# UNITED STATES PATENT AND TRADEMARK OFFICE

10/762,467

<b>Office Action Summary</b>	<b>Application No.</b>	<b>Applicant(s)</b>	
	10/762,467	MORI, MAKIKO	
	<b>Examiner</b>	<b>Art Unit</b>	
	GRANT D. SITTA	2629

FIG.2

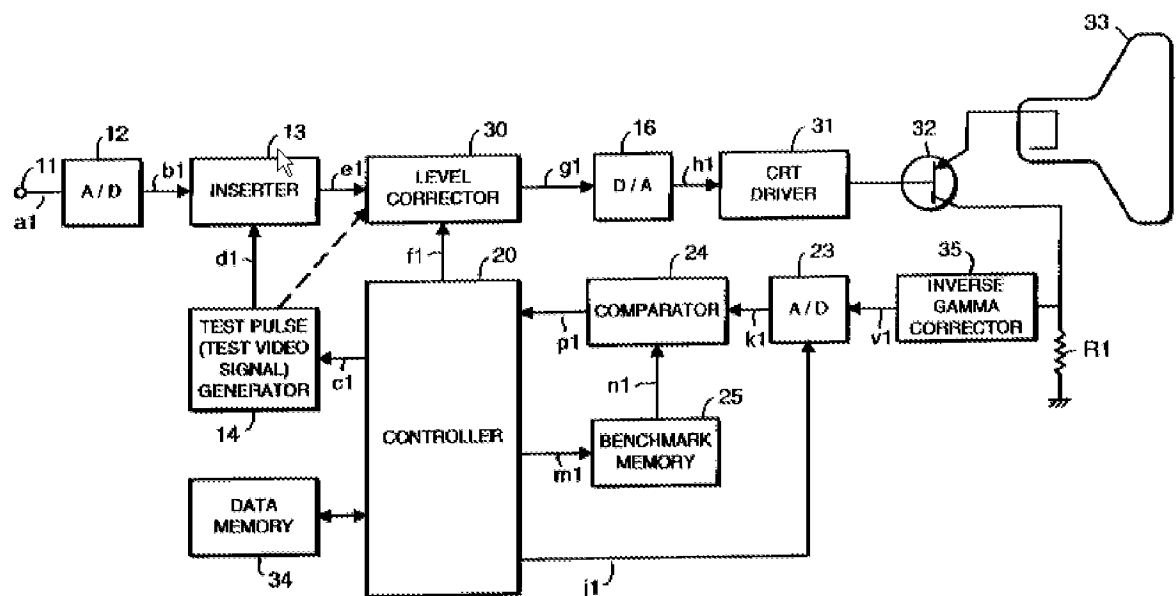
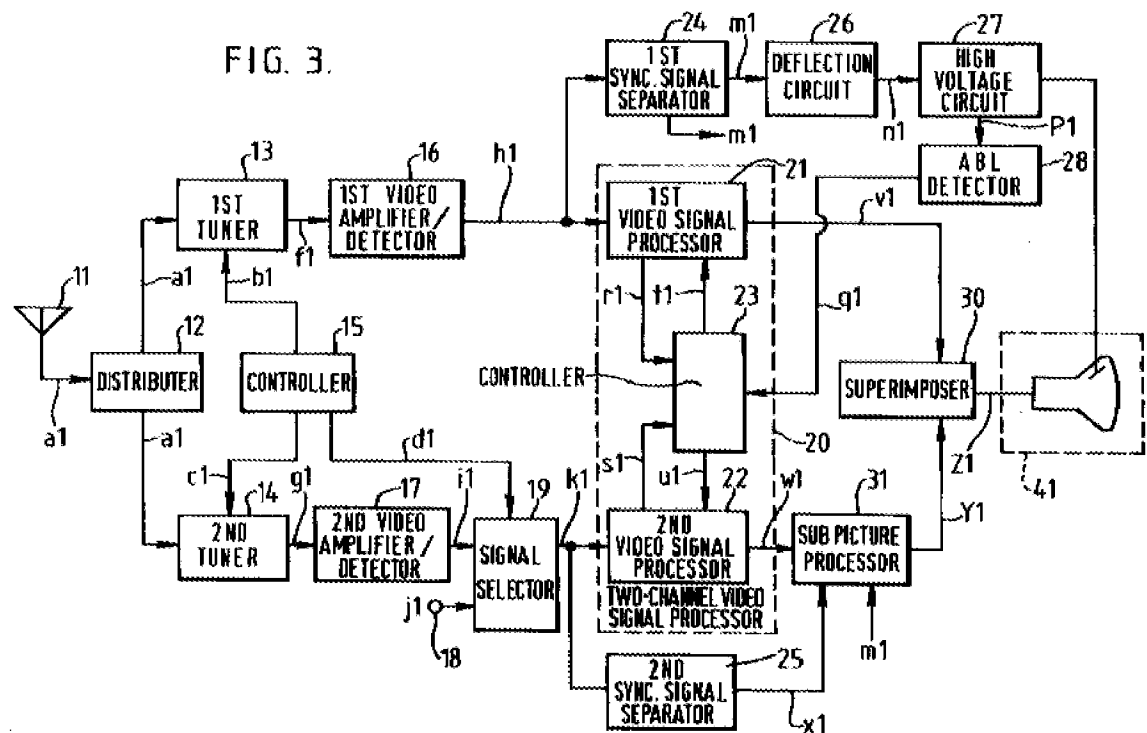
Tsuzuki teaches an automatic brightness correction apparatus for automatically correcting the brightness property of the image display device is configured to insert a test pulse at a predetermined level within a level range including an intermediate level to the video signal and displays the image of the test pulse on the video image display device, detect a deviation of the brightness of the image of the test pulse displayed on the video image display device from a benchmark, and correct the level of the video signal based on the detected deviation. While Tsuzuki teaches using a test pulse the claim language fails to preclude from using a test pulse. Examiner asserts the modification, Tsuzuki in view of Yamaguchi would allow wherein said display brightness feature value detecting circuit receives the superimposed video signal output from said

superimposing circuit and calculates, before the superimposed video signal is input to the display panel, the display brightness featured value from the superimposed video signal in which textual information or an icon is superimposed.

Yamaguchi teaches a superimposing circuit fig. 3 (30) shown below. The ABL Examiner notes, though the ABL is considered from the superimposed circuit corrections are made to the brightness for a 1<sup>st</sup> video signal independently fig. 4 (signal from  $g_1$  and (211)).

FIG.2

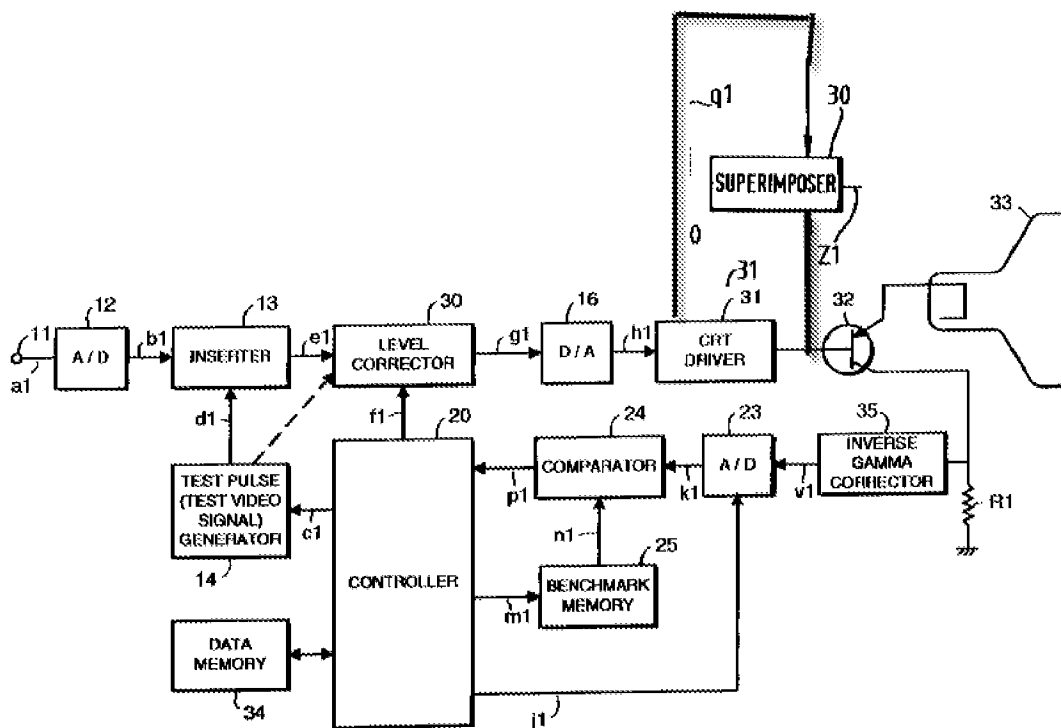
Examiner asserts it would have been obvious to one of ordinary skill to modify the brightness correction means of Tsuzuki, and insert the superimposing circuit (30) at the final stage of Tsuzuki, i.e., between (31 and 32 shown in fig. 2 see the proposed modified circuit below), in order to provide a means that does not limit brightness of one main picture element when compared with one sub picture element see col. 3, lines 40-67. Examiner notes, brightness detection is done in the final stage, see element (32), before the superimposed image is sent the display (33).
